31/6 10234 Montgomery Ave.
31/6-90F Lot 15

PROPOSAL PRESENTED TO THE HISTORIC PRESERVATION COMMISSION
FOR PRELIMINARY CONSULTATION ON APPLICATION
FOR AN HISTORIC WORK PERMIT

BEFORE THE MONTGOMERY COUNTY HISTORIC PRESERVATION COMMISSION

Application of Avery Flaherty Properties, Inc.

SITE PLAN GEORGIAN MASSING

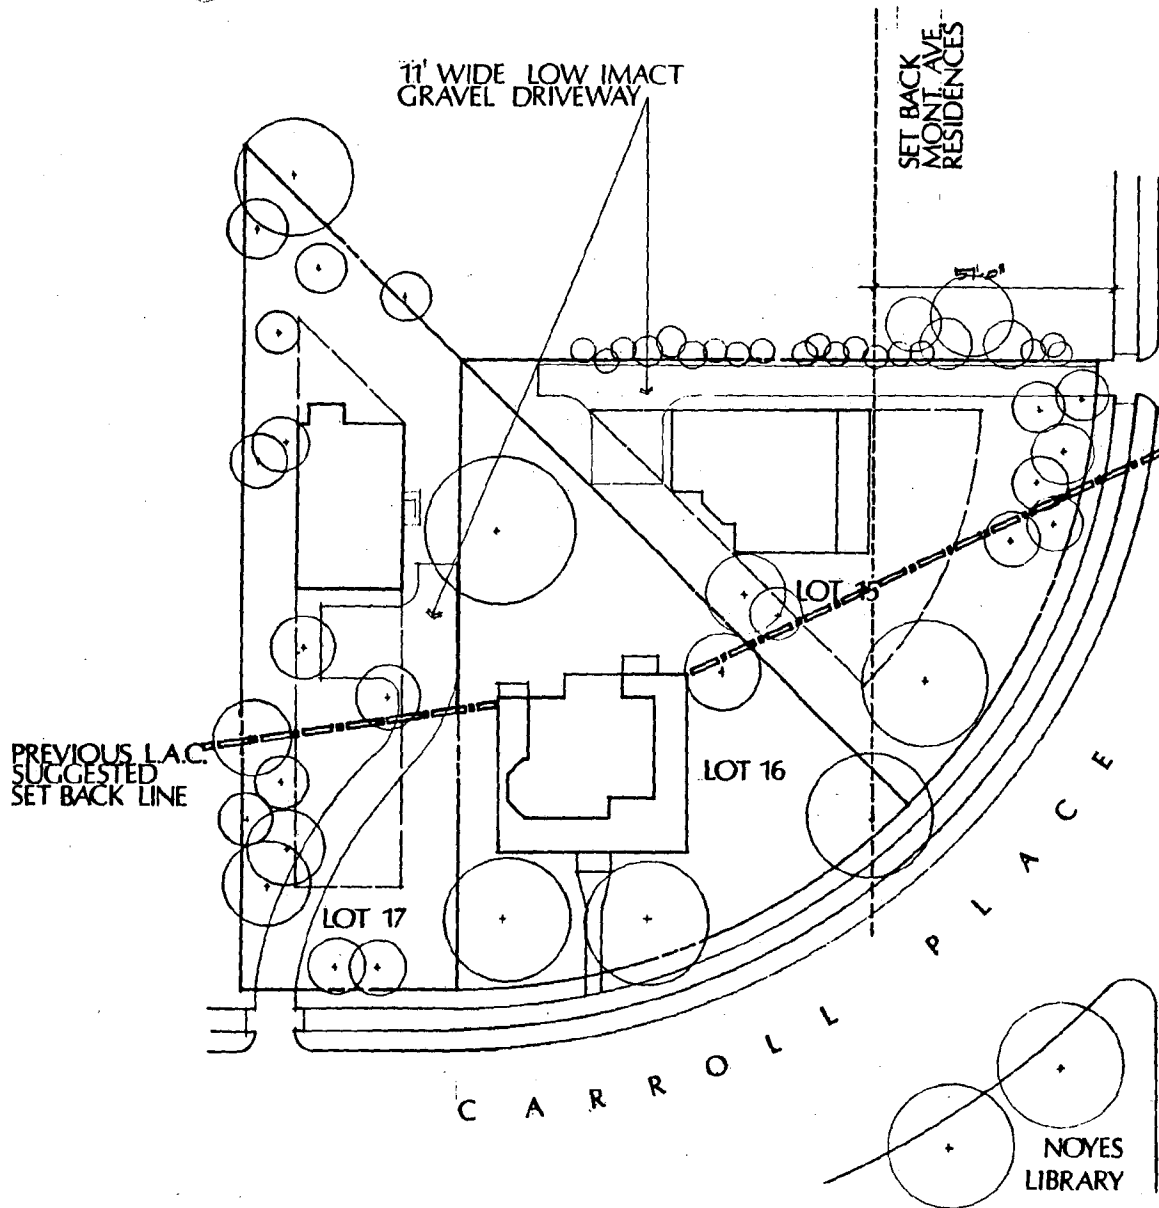
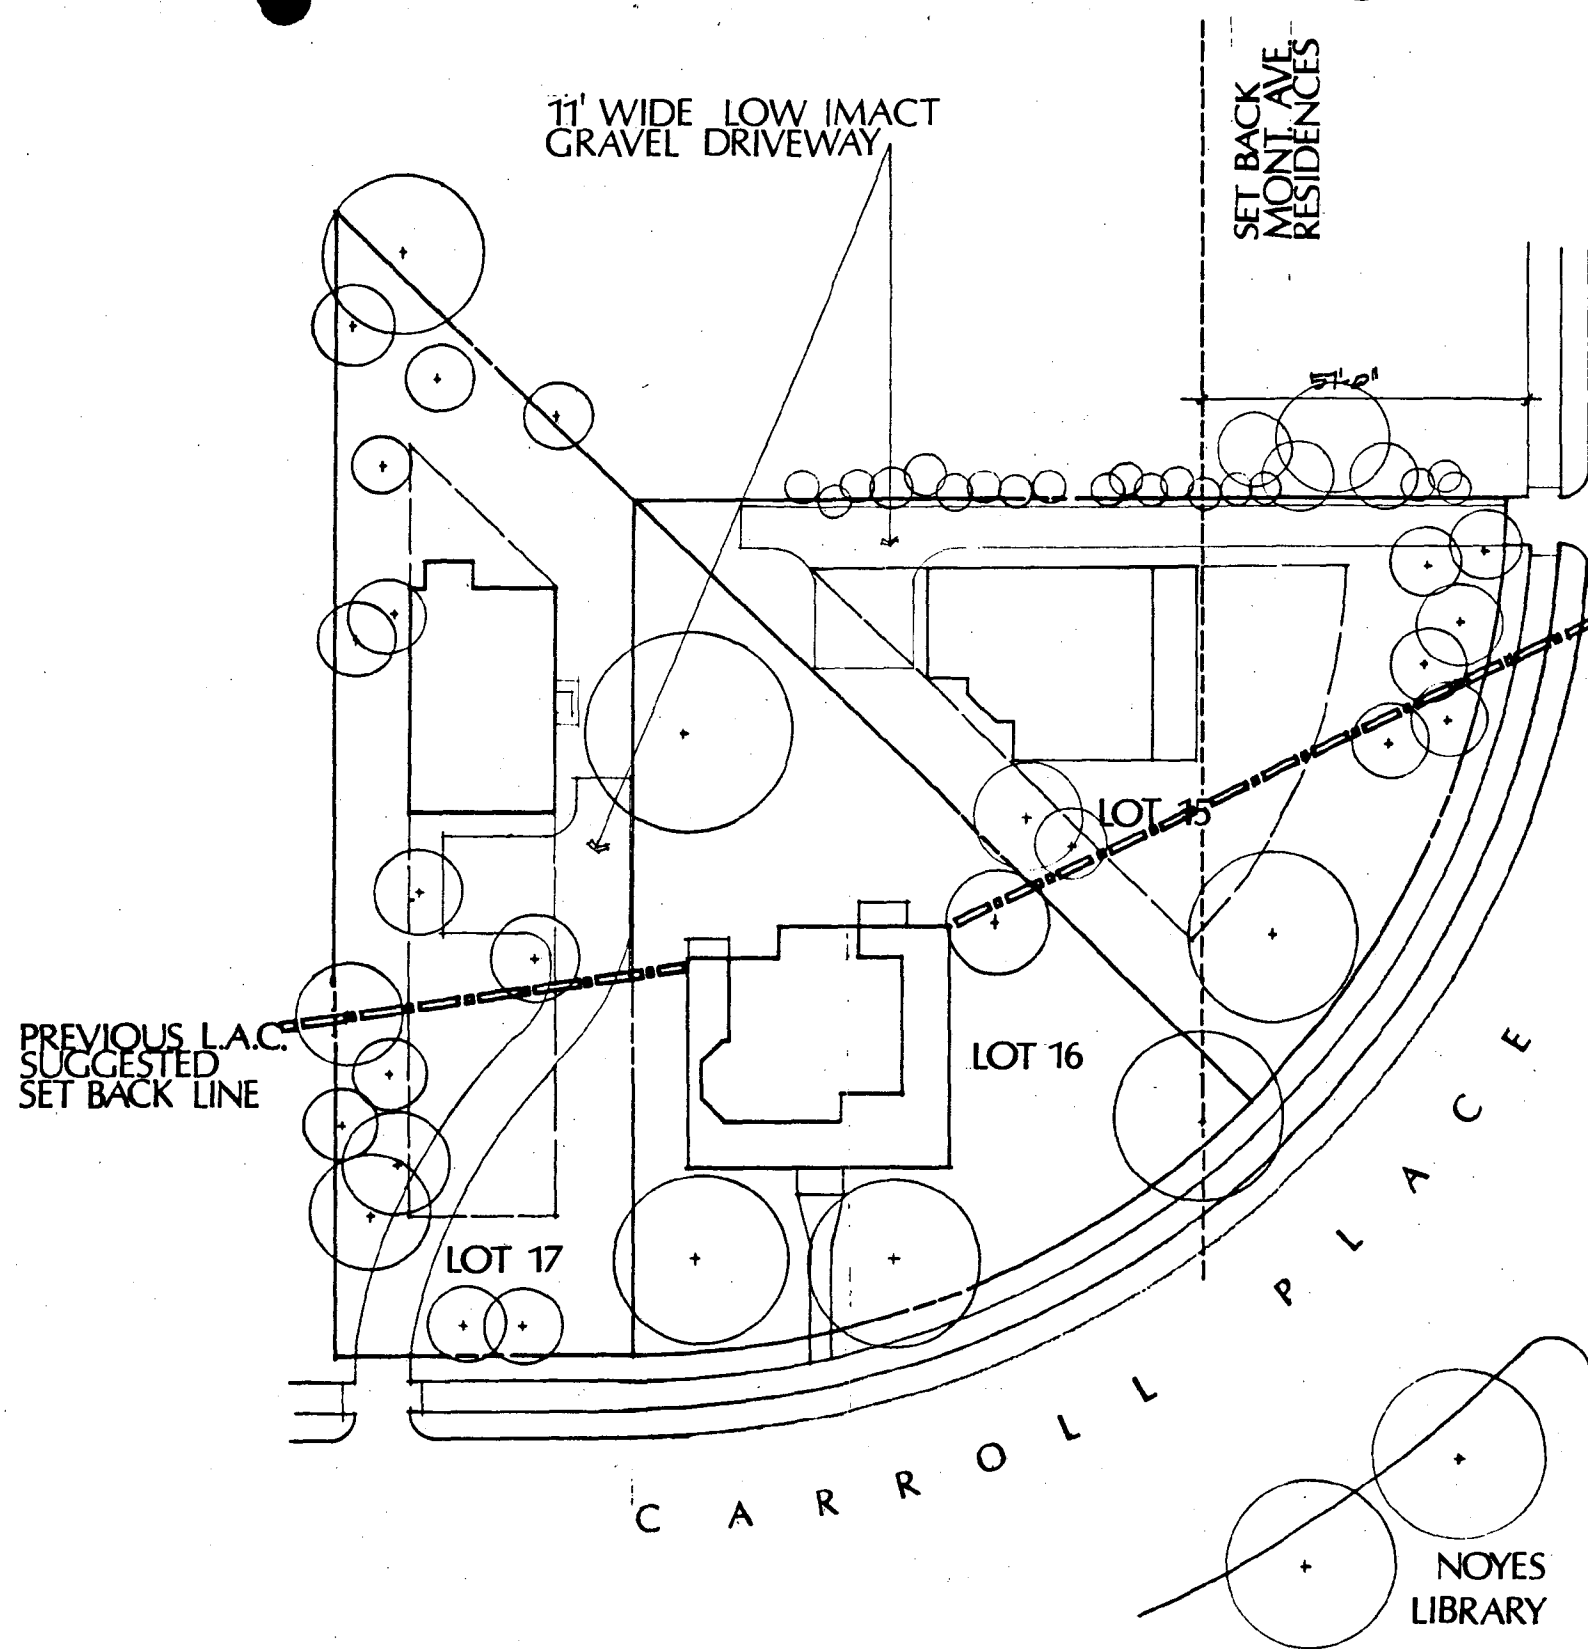
Mr. Little also stated that the Georgian design of the proposed structure would result in a very boxlike configuration, devoid of breaks or detailing until it reaches the high roof line. Mr. Little went on to say that the design of the proposed four-square house may be appropriate along Montgomery Avenue; however, in his opinion, the design is not compatible with the Victorian-style structures of Carroll Place, specifically the Noyes Library and the residence on Lot 16.

In his testimony, George Martin, the applicant's architect and spokesperson, suggested a Georgian-style house be built on Lot 15 which reads as a single unarticulated structure with very little detail. Although the design may echo the four-square residences along Montgomery Avenue, the proposed structure does not relate to the other more Victorian properties to its south, specifically the historic resource on Lot 16 and the Noyes Library. Thus, the architectural cohesiveness of the district's streetscape as noted in the Master Plan amendment would be destroyed.

Alternatively, a Georgian style house is appropriate for Lot 15. Whereas the neo-Victorian would serve to accentuate the row of Victorians to the west, the proposed Georgian would serve to punctuate the rhythm of houses on the west side of Montgomery Avenue by terminating the sequence of the existing Georgian style houses. This Georgian is congruous with the residences to the south and east on Montgomery Avenue since they are Georgians. The house would also continue the existing rhythm because it shares the same setback as the residences immediately to the north of it with deep front yards. The proposed Georgian has the typical front porch with three-quarter length Tuscan columns which are also present in the existing Georgian houses around the area. It is in essence derived from the archetypal southern Georgian house which is the type from which most Georgians in the area were derived.

G1

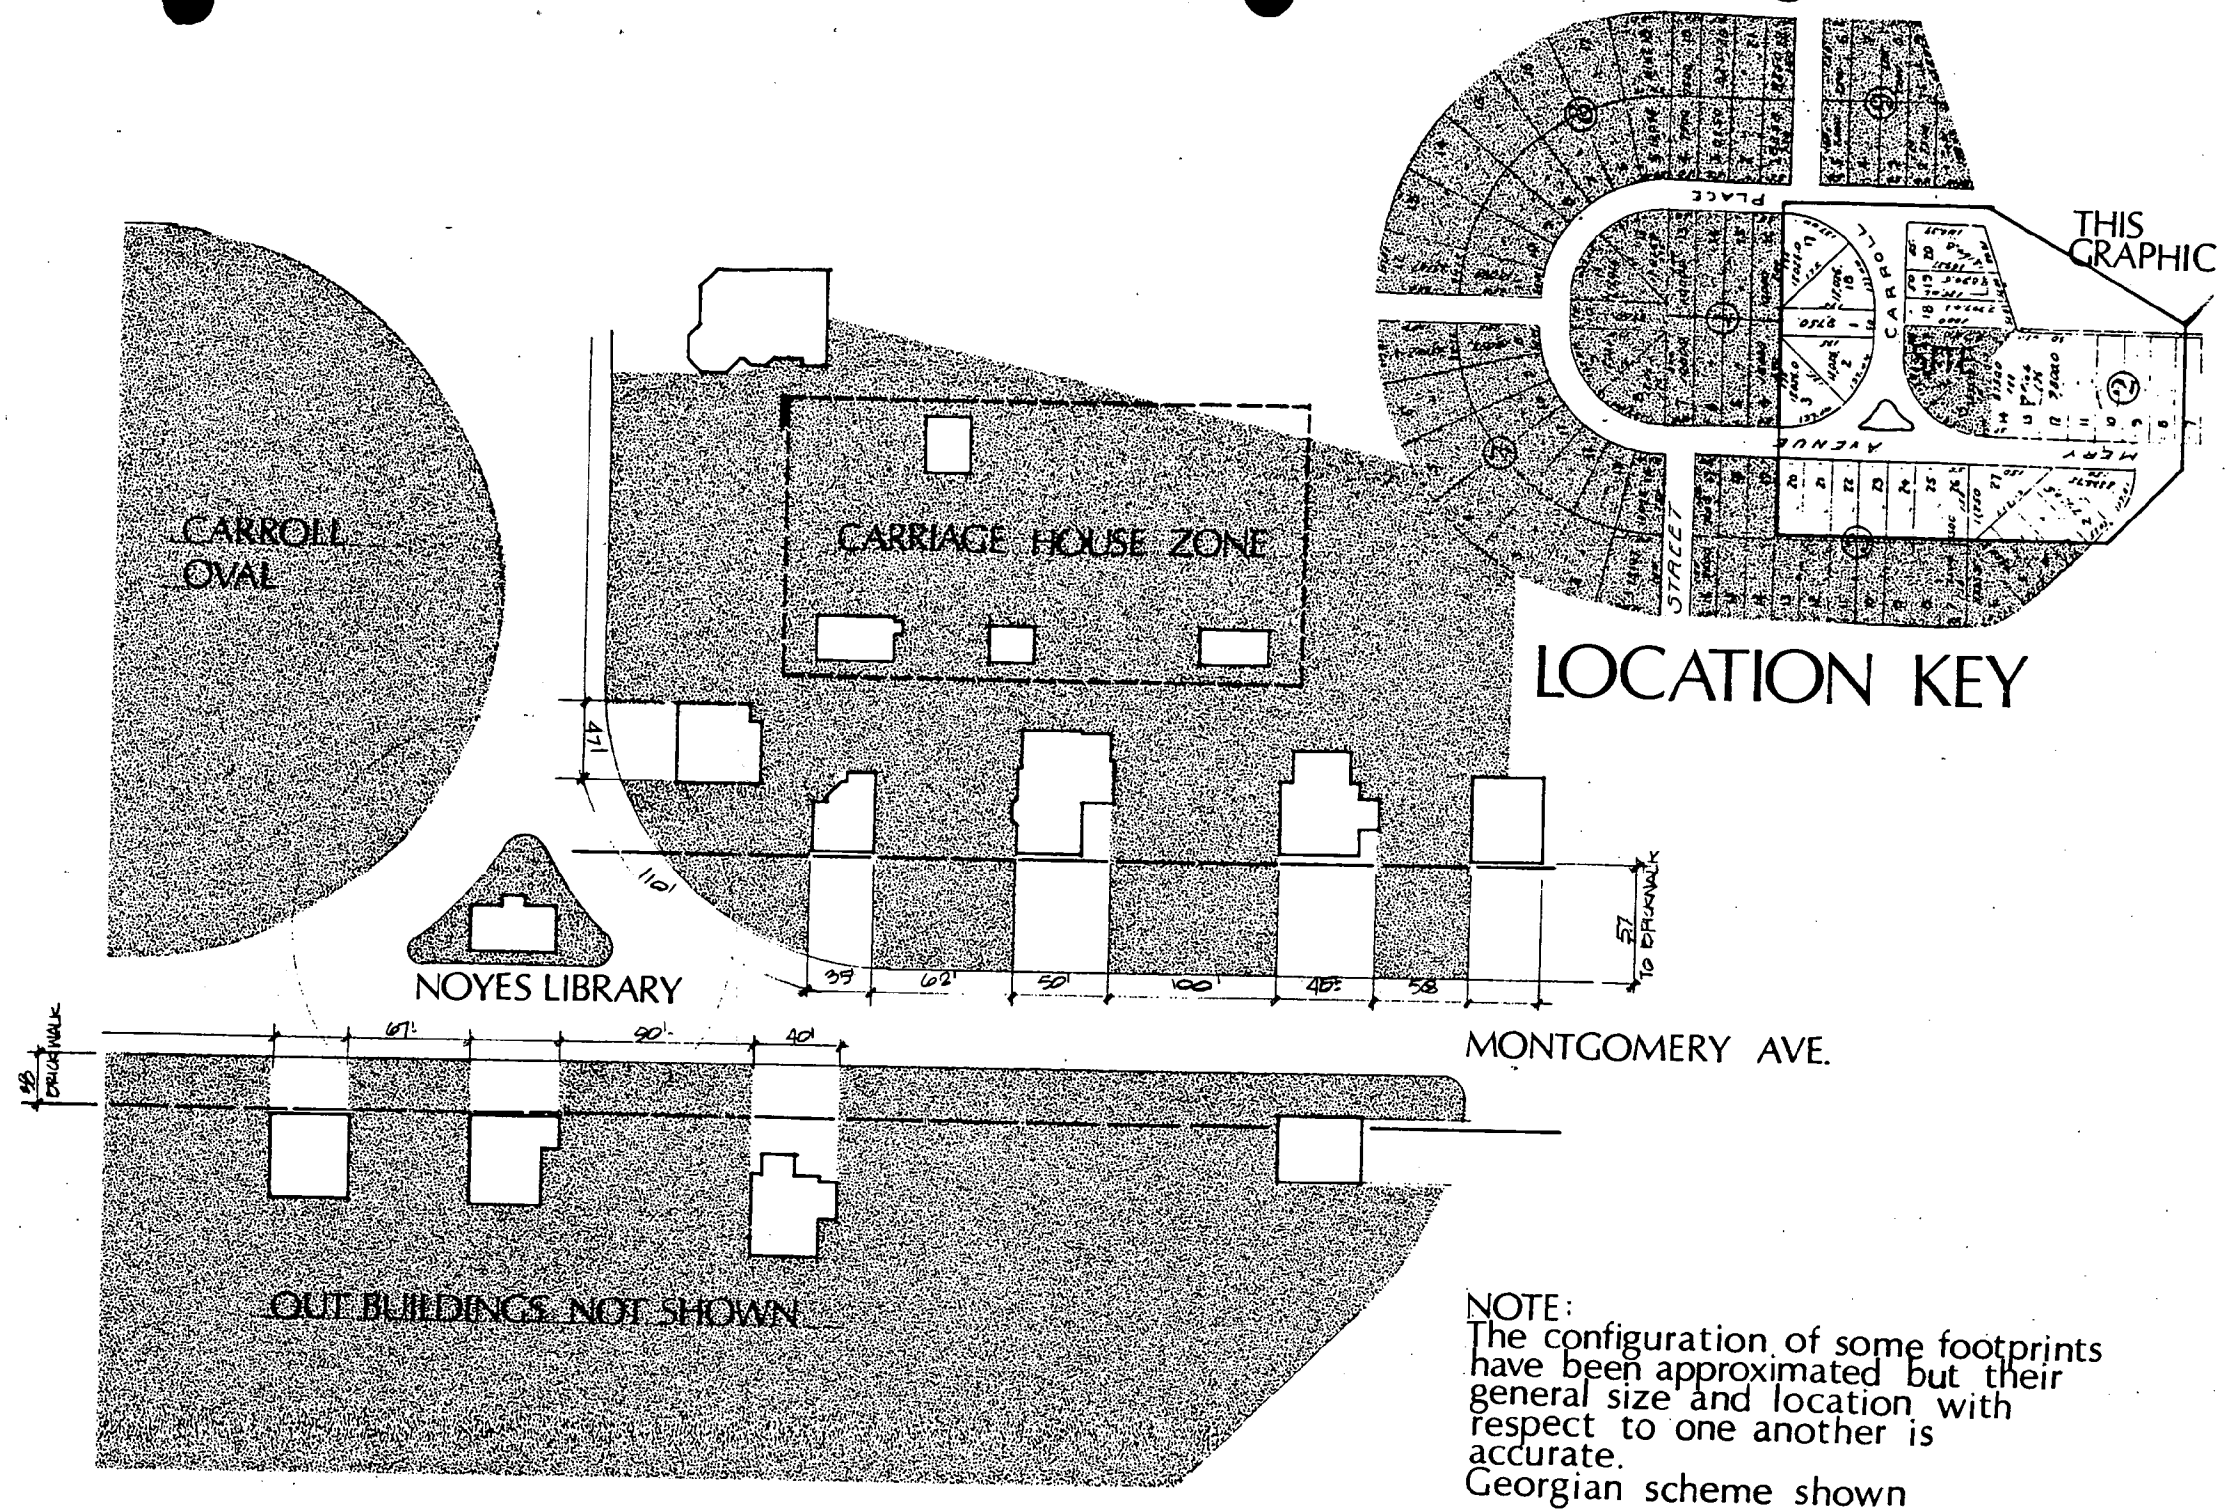
Dr. Ray Shulman, Acting Chair of the Kensington LAP, testified that, in its review of the application on May 6 and 8, 1990, the Kensington LAP found the proposed plans for new construction would "interfere with the existing rhythm of the buildings as they exist in this area of Kensington" (HPC Exhibit 1, page 11).

He stated that the houses in the immediate area of the historic district are of "showcase quality." Dr. Shulman further stated that these houses average 118 feet apart and averaged three lots per house, with an average frontage of approximately 159 feet. Dr. Shulman went on to say that, historically, these multiple-lot sites have been transferred undivided from property owner to property owner for more than 100 years, thus establishing a development pattern of houses built in a spacious garden setting.

Mr. Don Little, speaking on behalf of many of the citizens of Kensington, presented an analysis of the average percentage of yard coverage (defined as the ratio of house footprint to the total yard coverage of primary resources within the core of the historic district). The analysis indicated that the average yard coverage in this area of the historic district is approximately eight percent and that the proposed new construction for Lot 15 would result in a yard coverage of 14.8 percent, thus significantly altering and destroying the existing rhythm between the historic structures and the surrounding open space.

Graphic G1 illustrates that the proposed structures can be placed in harmony with the existing rhythm of the area. The proposed structure for Lot 17 is discussed first, and then two alternatives for Lot 15 are explained.
